DEVELOPMENT DETERMINATION PANEL MEETING

WEDNESDAY 25 SEPTEMBER 2024

ITEM 3.1	DA2024/0647 - 14 THE CIRCLE BILGOLA PLATEAU - ALTERATIONS AND ADDITIONS TO A DWELLING HOUSE
----------	--

DEVELOPMENT APPLICATION ASSESSMENT REPORT

Figure 1: Section AA - Indication of proposed works (windows) that are above 8.5 metres in red

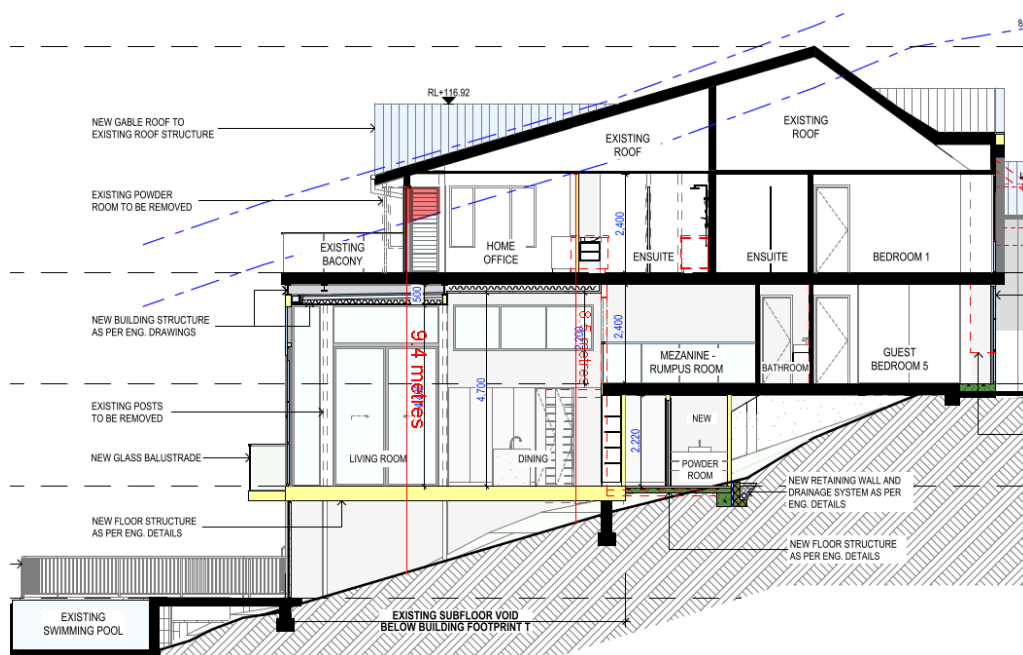
Whilst it is noted that a section of the proposal (new gable roof) extends above the 10.0 metres exemption (which has been accompanied by a Clause 4.6 Variation Request), the replacement windows sit below the allowable exemption at 9.4 metres in height (refer to below Figure 1). This area as existing consists of windows, this proposal seeks to amend the window layout and add additional windows. As the dwelling consist of an existing height above 8.5 metres, it is not possible for the windows to be located below this height plane. It is noted however that the majority of built form is situated below the 8.5 metres building height standard.

Figure 2: Section AA - Indication of proposed works (gable roof) that are above 8.5 metres in red shading. Note: New windows are subject to 10.0m requirement - refer to Clause 4.3 Height of Buildings.

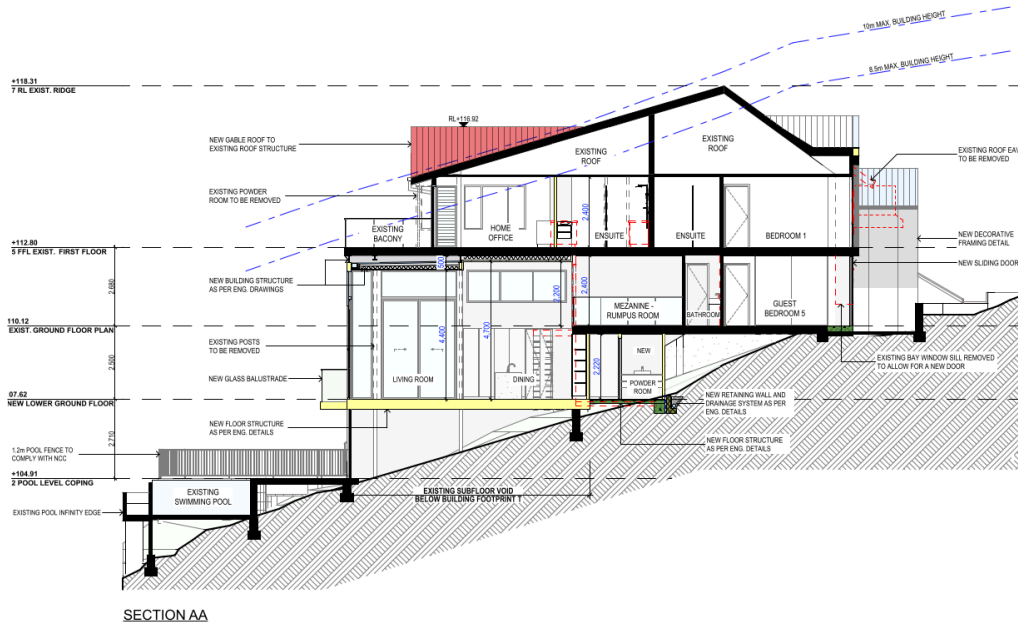
Proposed: 11.6 metres

Percentage of variation: 36.5%

Figure 3: Eastern Elevation (red shading indicates encroachment).

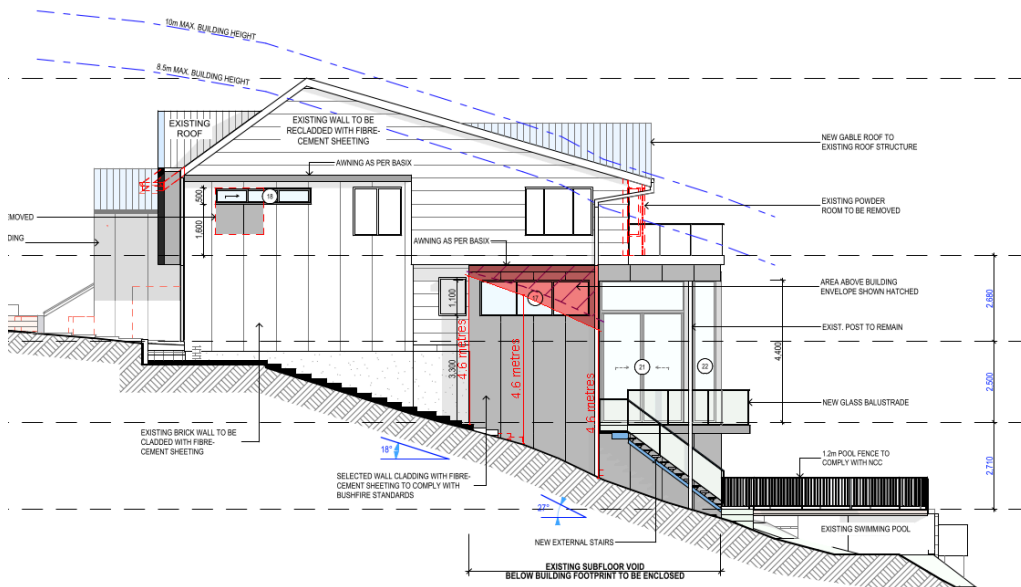
Clause D3.9 Building Envelope generally requires development to be sited within a 3.5 metre building envelope to ensure the bulk and scale of the built form is minimised.

When subject to this envelope requirement, the proposed development exhibits an encroachment on both the eastern and western elevations (See Figure 3 + 4 below). It is noted that the envelope breach has been reduced via amended plans.

Figure 4: Western Elevation (red shading indicates encroachment, blue shading indicating previous encroachment).

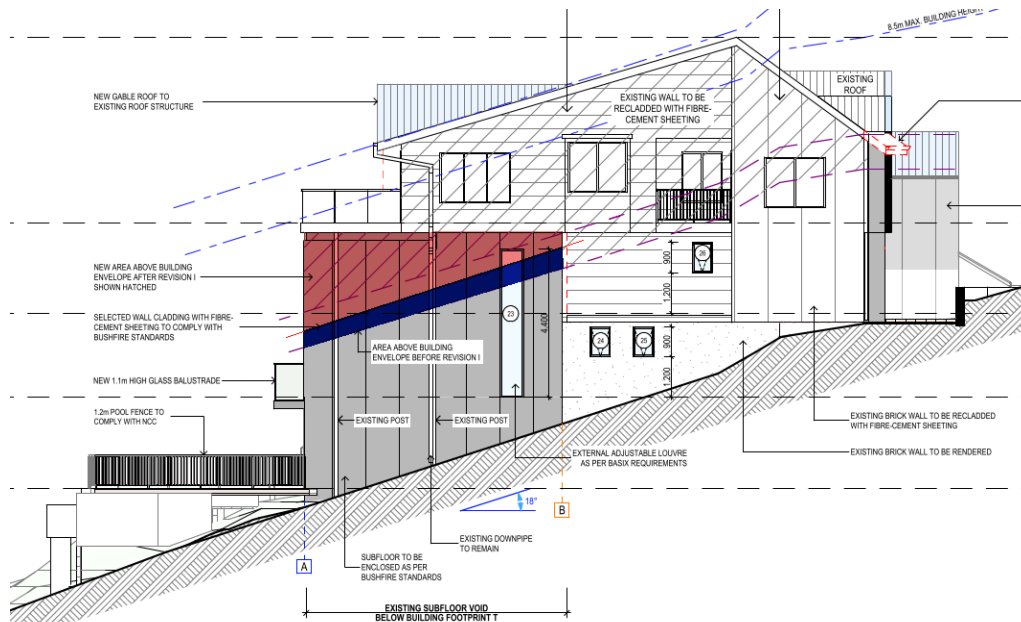
It is noted that the envelope breach to the west (when assessed against the standard 3.5 metre requirement) is as a result of the subfloor being enclosed to provide habitable space below the upper floor. The setback to this area follows the existing line of the building and is not directly adjacent to any neighbouring structures but rather vegetation.

Figure 1. Long Section A-A (red highlighting height variation over 8.5m)

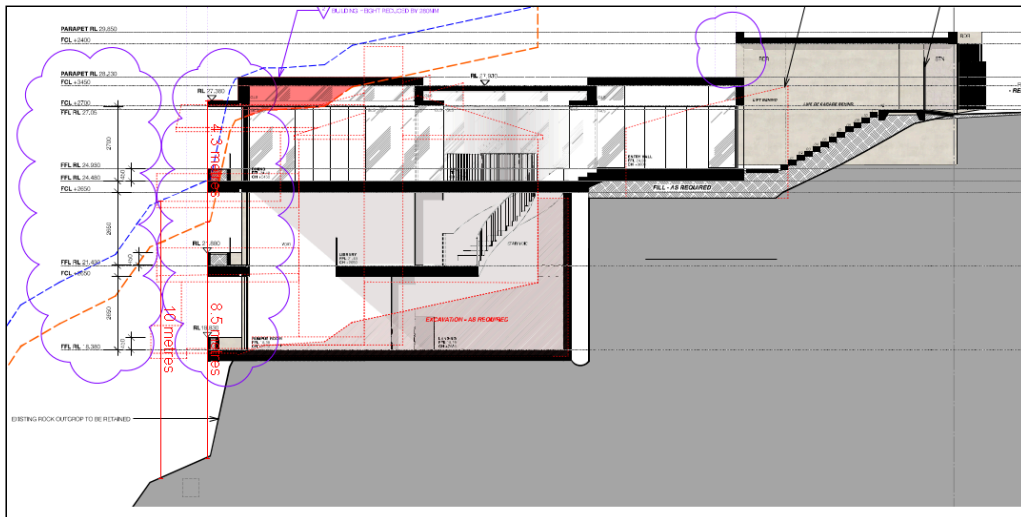
Proposed: 12.8m

Percentage of variation: 50.59% (4.3m)

Figure 7. North Elevation (red highlighting building envelope numerical non-compliance)

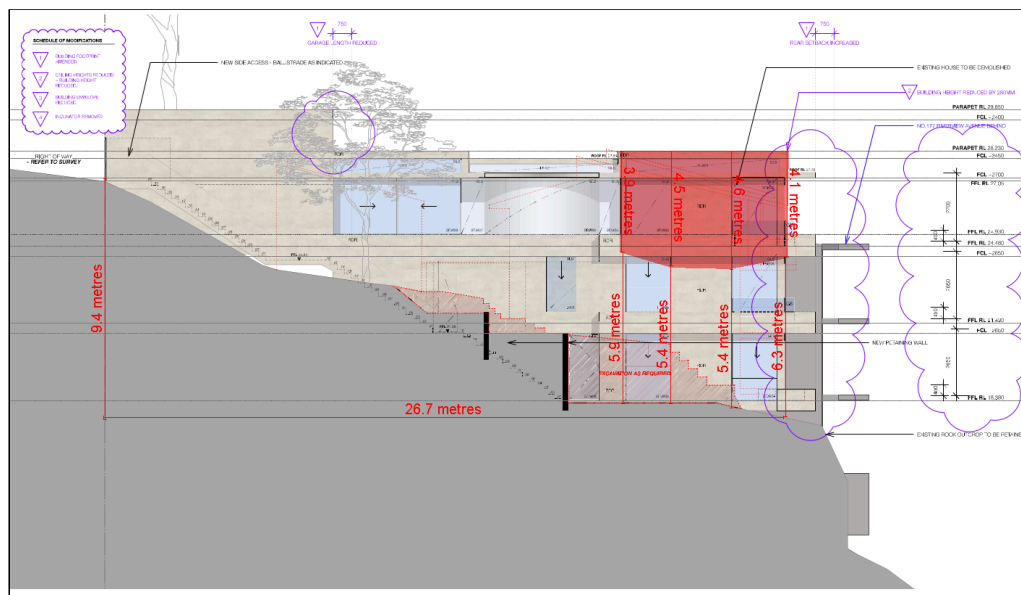
The proposal presents variations along the Northern Elevation (see Figure 7) and along the Southern Elevation (see Figure 8). In this instance, the proposal is considered to be supportable, despite the extent of building envelope variations, as the site is subject to steep sloping topography and a limited building footprint as a result of the right of way at the front of the site, and the Pittwater Foreshore Building Line at the rear of the site. Furthermore, it is considered that if the building mass were moved further east (towards the street) this would result in greater solar access impacts to the site to the south, and also present greater bulk and scale as viewed from the streetscape. It is considered that the location of the proposal is appropriate and is integrated into the landform and will present as a single storey development from the streetscape. The location of the building envelope variation is attributed to the topography of the site, and it should be noted that the proposal is comparable to the developments located on the low side of Riverview Road that include multi-level designs due to the site constraints.

Figure 1 - extent of height breach indicated in red

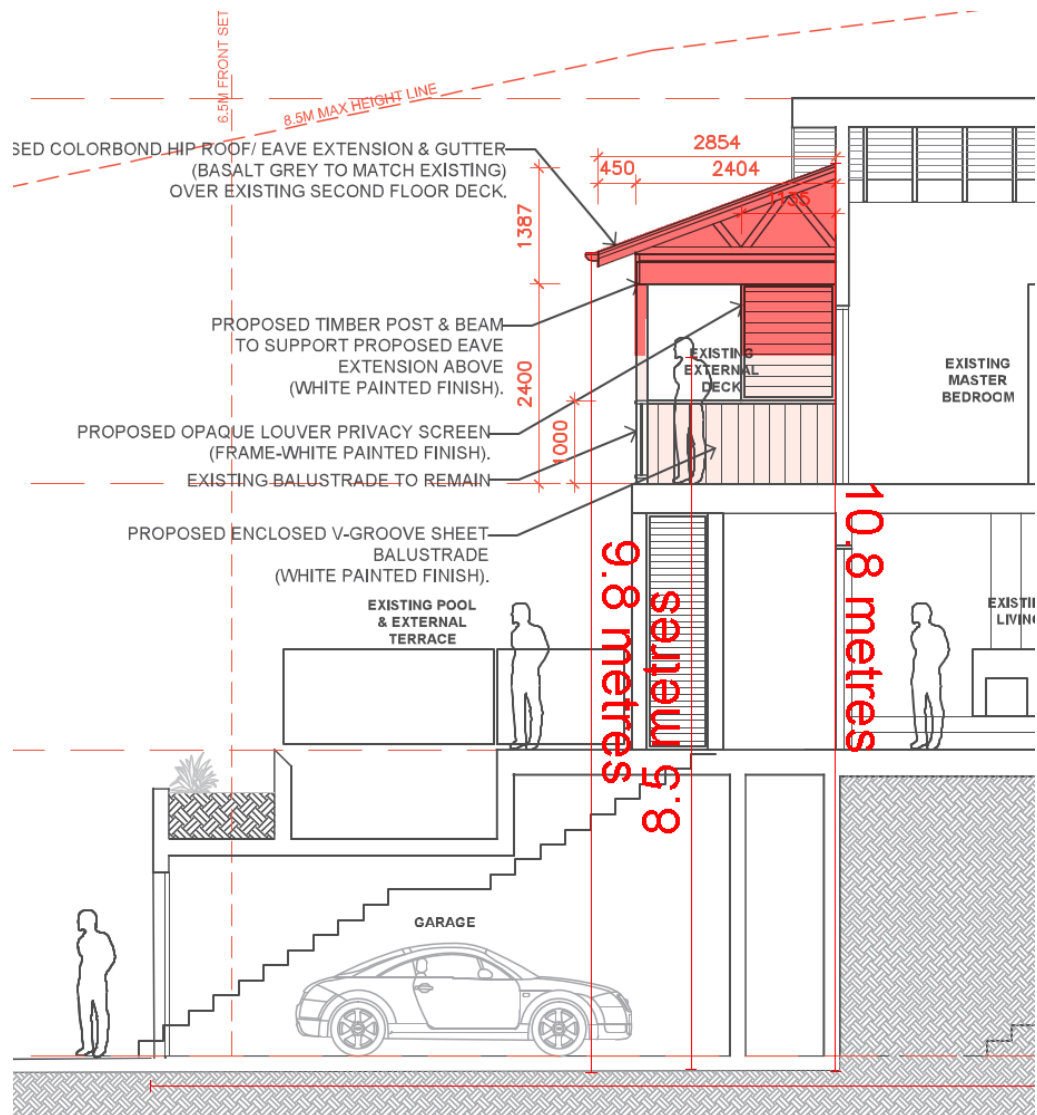
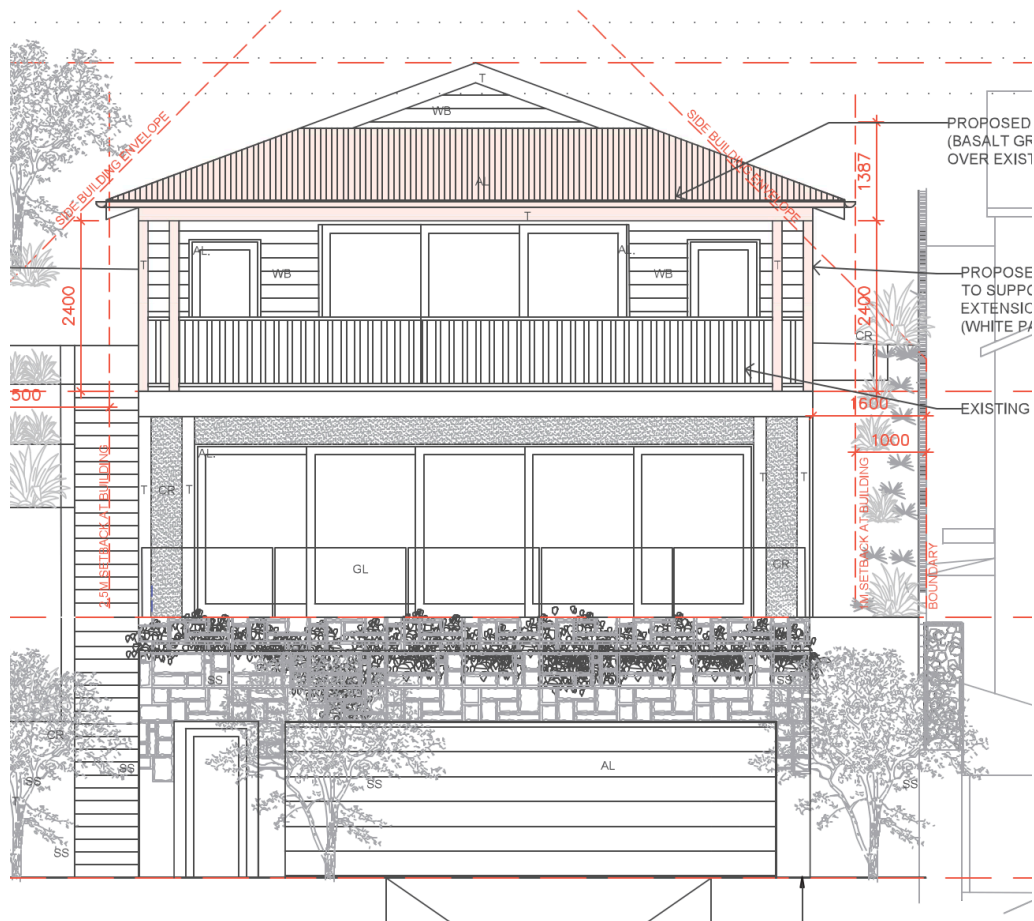
Proposed: 10.8m

Percentage of variation: 27%

Figure 2: extent of building envelope breach

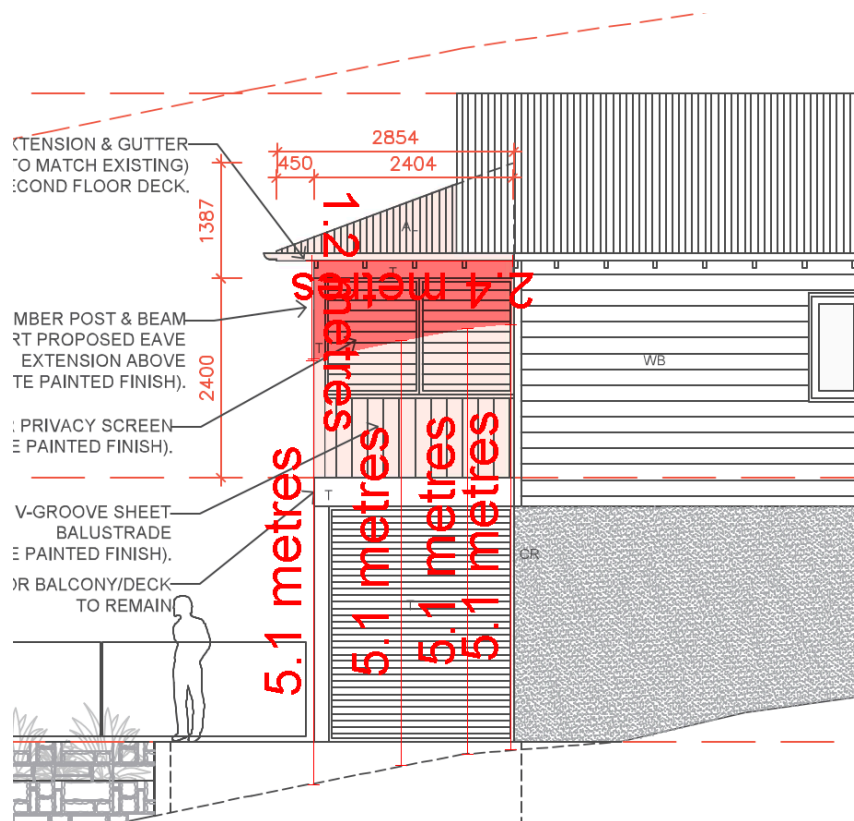
The western elevation presents an encroachment of 1.2m in vertical height for a horizontal length of 2.4m, resulting in a maximum variation of 23.5% (1.2m), as shown shaded red below.

It is important to note that this envelope breach relates only to privacy screening along the western edge of the existing deck, and the building footprint is situated on a slope over 30%. As such, the breach is associated with an unenclosed structure with no provision of any windows, providing an improved planning outcome to the existing open air deck with respect to privacy and amenity. Furthermore, the western wall at the ground and first floors is compliant with the western side building line at 1.6m.
